HPAC Committee Agenda

August 6, 2025

PLANNING ACTION: PA-T1-2025-00272

SUBJECT PROPERTY: 40 Granite Street

PROPOSED
 SOUTH & WEST
 EXT. ELEVATIONS
 DATE: 07/07/2025
 DRAWN BY: JDS
 SCALE: 1/4" = 1'-0"
 SHEET:

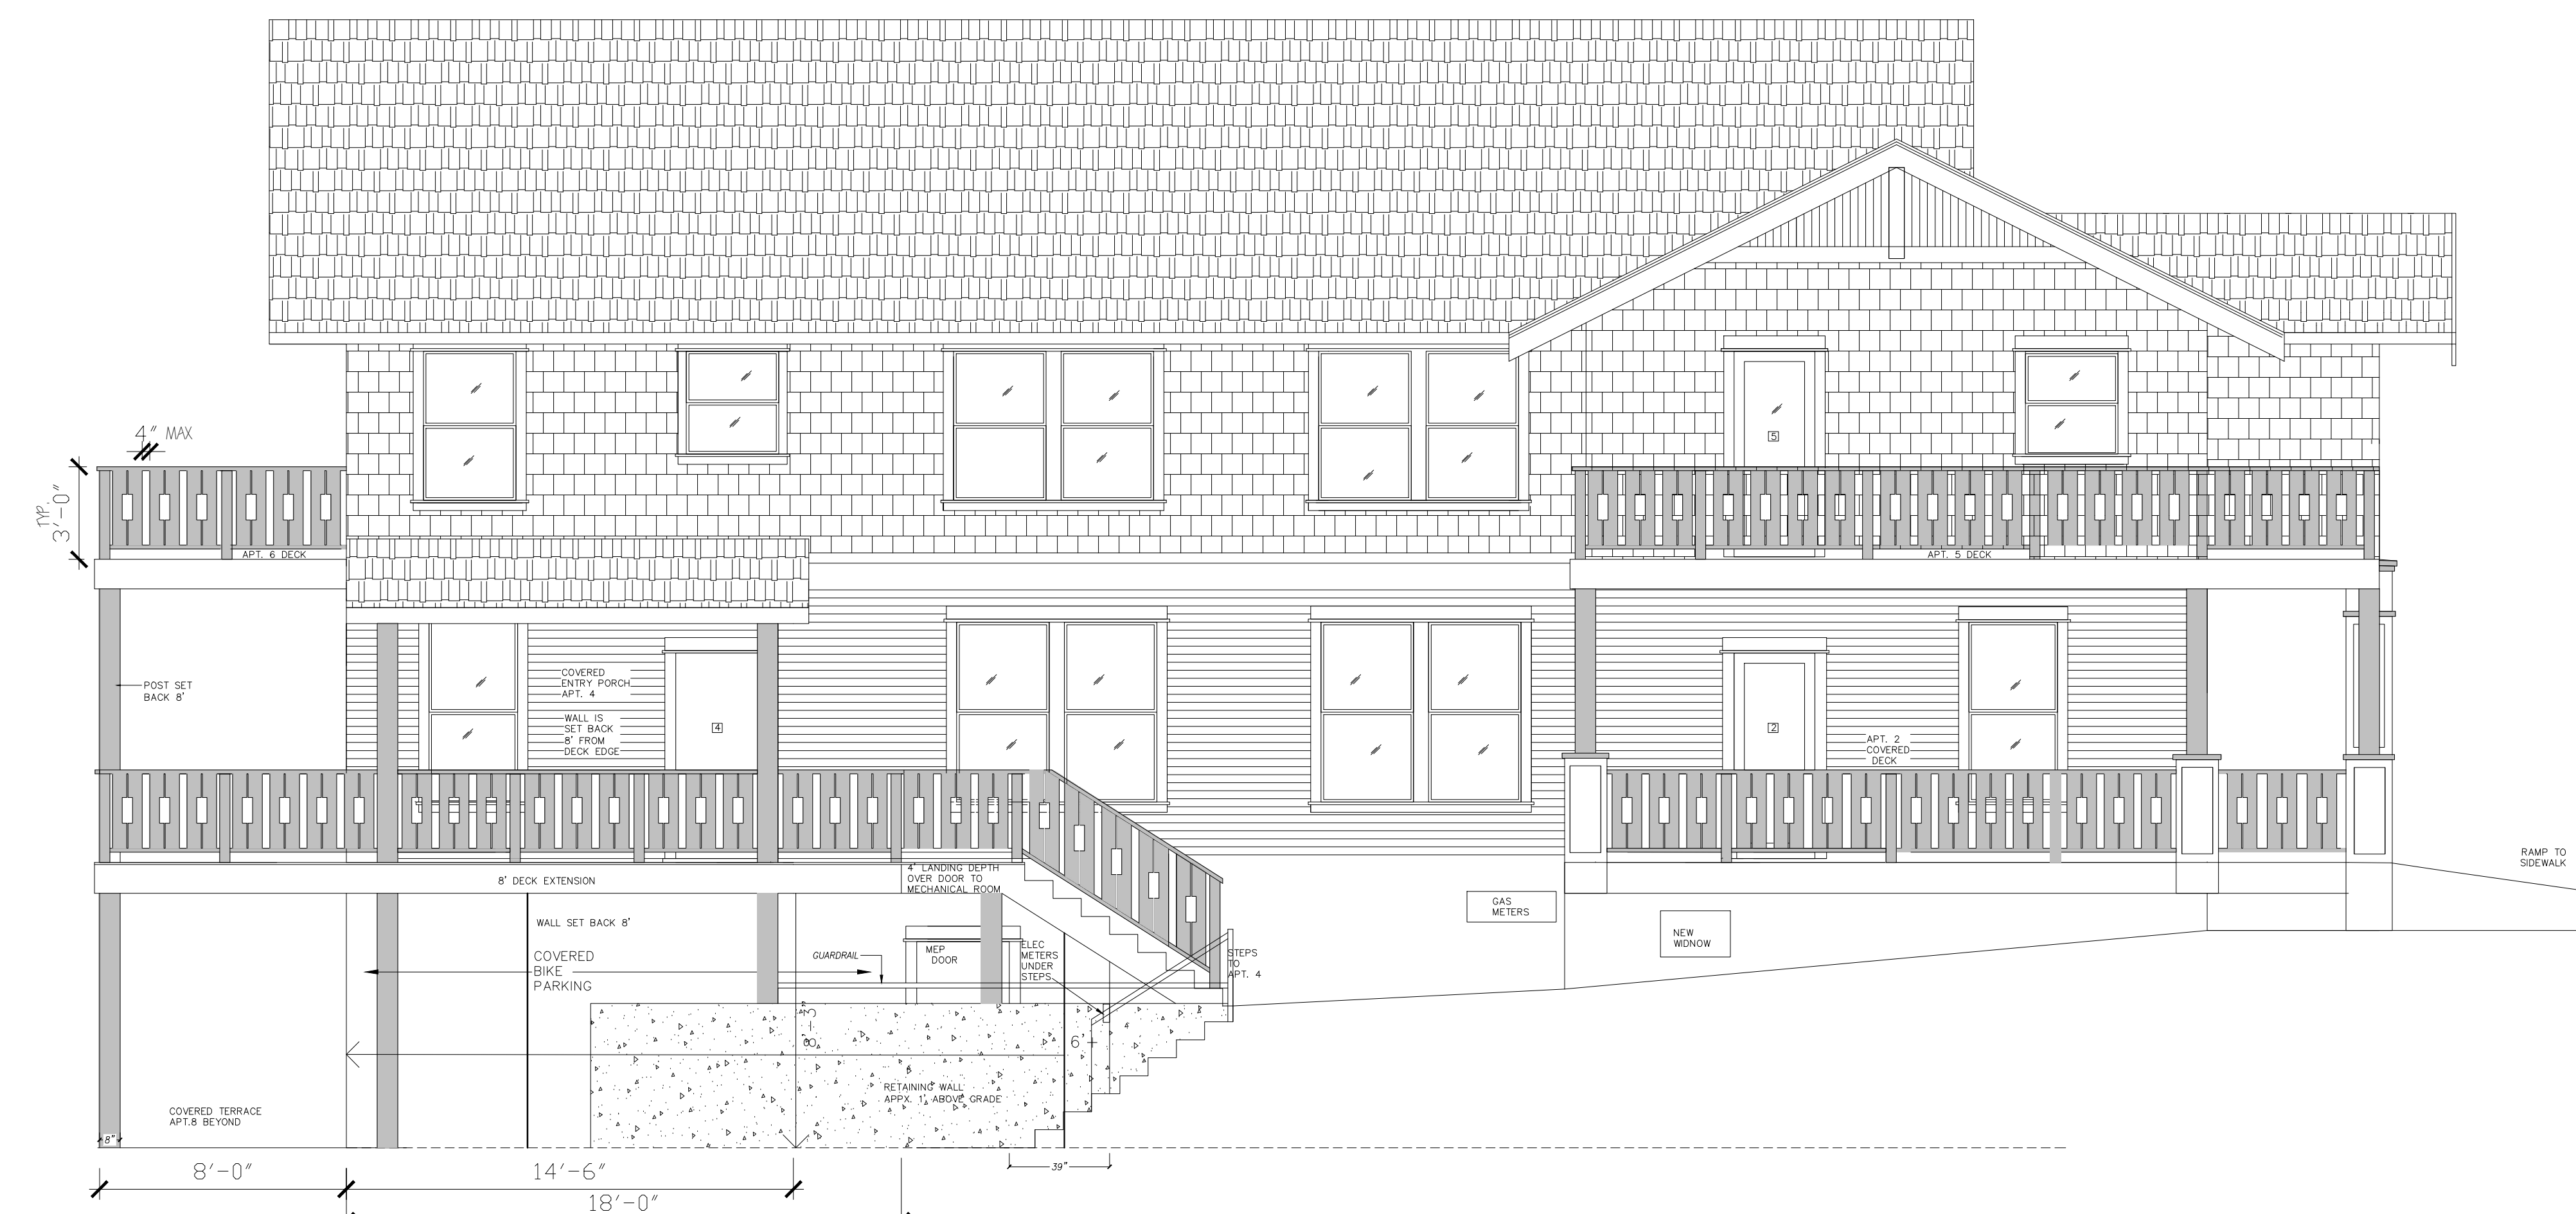
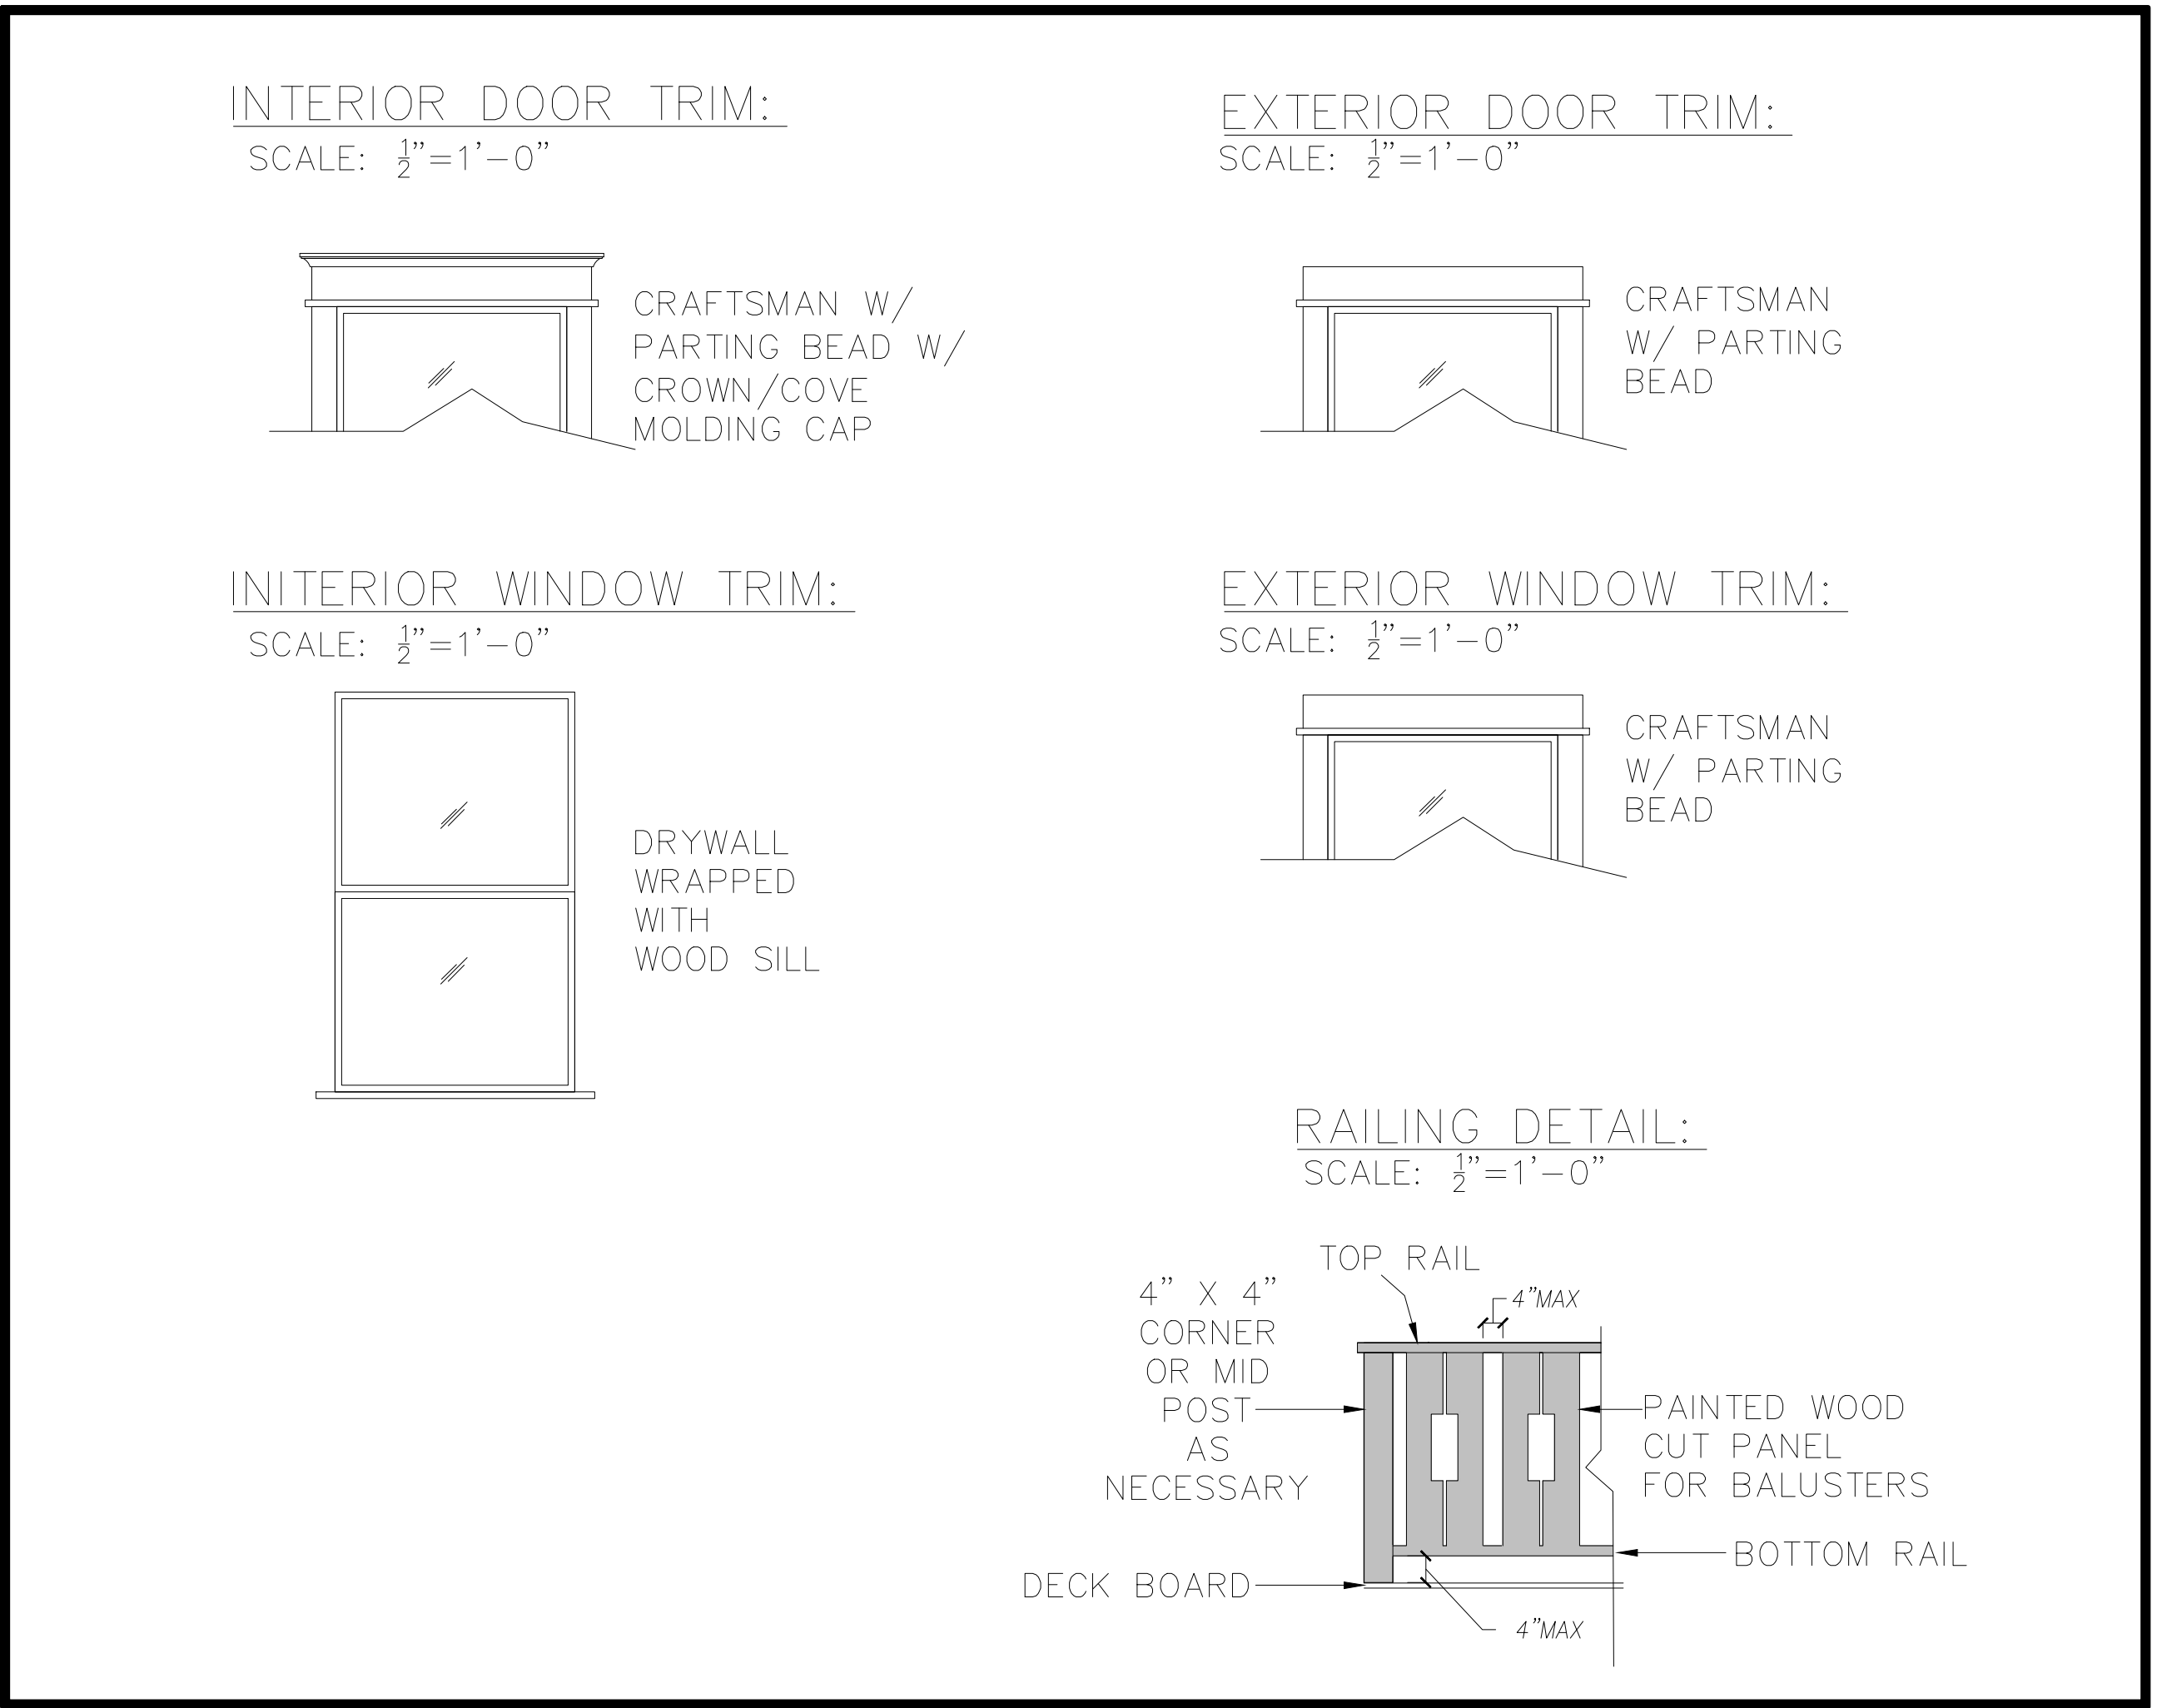
In initial review, the HPAC Review Board expressed concern with the proposed porches and decks suggesting that they were not historically compatible with a historic contributing resource. The pre-application submittal was limited to a site plan showing the placement of decks wrapping the front and rear of the building, without supporting elevation drawings.

Given the unique nature of the use as a historic eight-unit apartment building in a single family zone, the variety of deck and porch treatments in the immediate vicinity, the location in a transitional area between zones and historic districts, and the applicant's efforts to provide outdoor living space for each of the small apartments, staff believe there is a basis to approve the decks if HPAC finds that the design and material treatments proposed are compatible and that the placement on the street-facing façade does not overpower the existing historic home.

PROPOSED
EAST & NORTH
EXT. ELEVATIONS
DATE: 07/07/2025
DRAWN BY: JDS
SCALE: 1/4" = 1'-0"
SHEET:

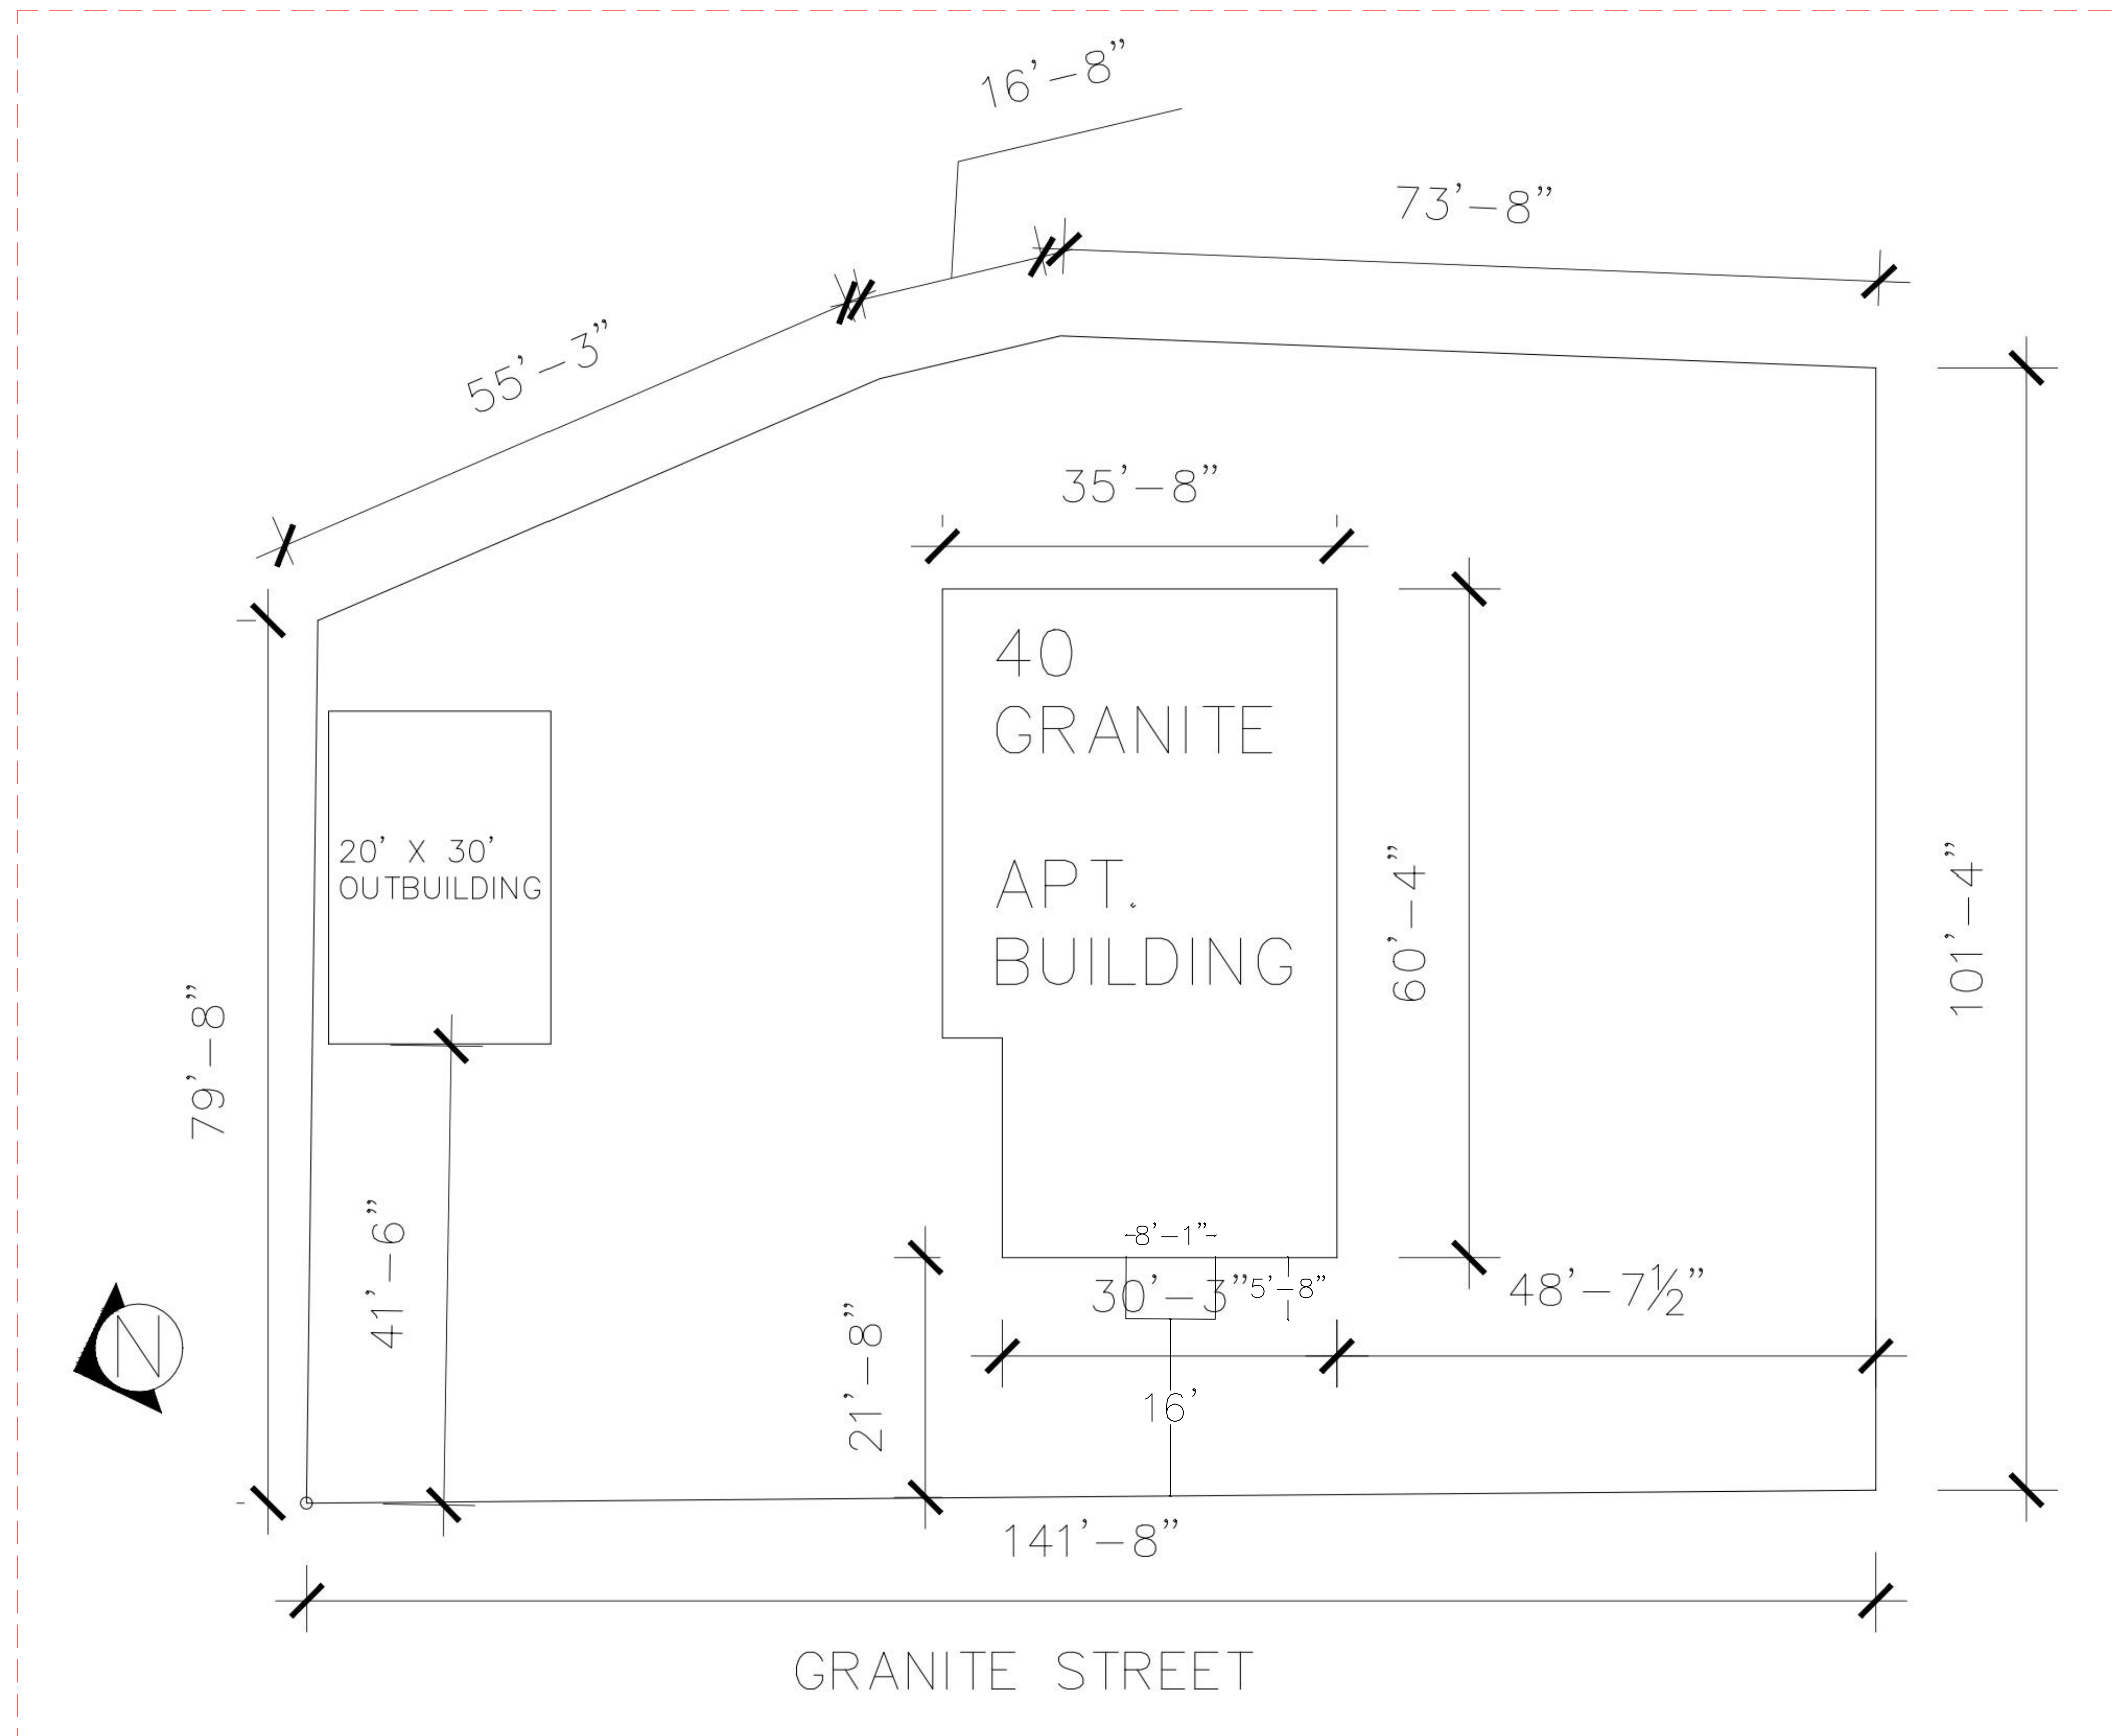
The historic survey document for the property (see above) suggests that the 1/1 wood sash windows are one of the elements that effectively relate to the history of the structure. The application notes that of all of the building's windows, only nine of the original 1/1 wood sash windows remain and all of the others have been replaced with vinyl windows over time. The application further indicates that all of the building's windows are proposed for replacement with the current proposal. The application materials do not provide specific details of the window replacements proposed.
